TELEPHONE SETS—831- AND 2831-TYPE IDENTIFICATION, INSTALLATION, CONNECTIONS, AND MAINTENANCE

1.001 This addendum supplements Section 503-702-101, Issue 6.

Fig. 9—831- and 2831-Type Telephone Set, Connections (Sheet 3 of 6)

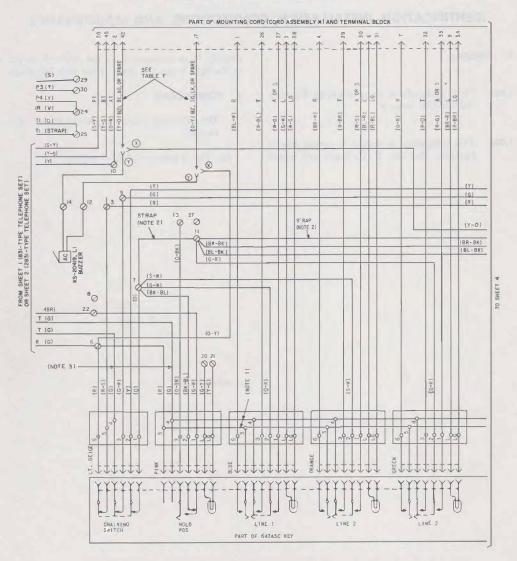
1.002 This addendum is issued to revise Fig. 9 to show the two T (G) leads are wired

directly from terminal F of the network to pin 4 of the light beige and pin 4 of the pink 508 plugs.

(a) Fig. 9 (sheet 3 of 6) — revised
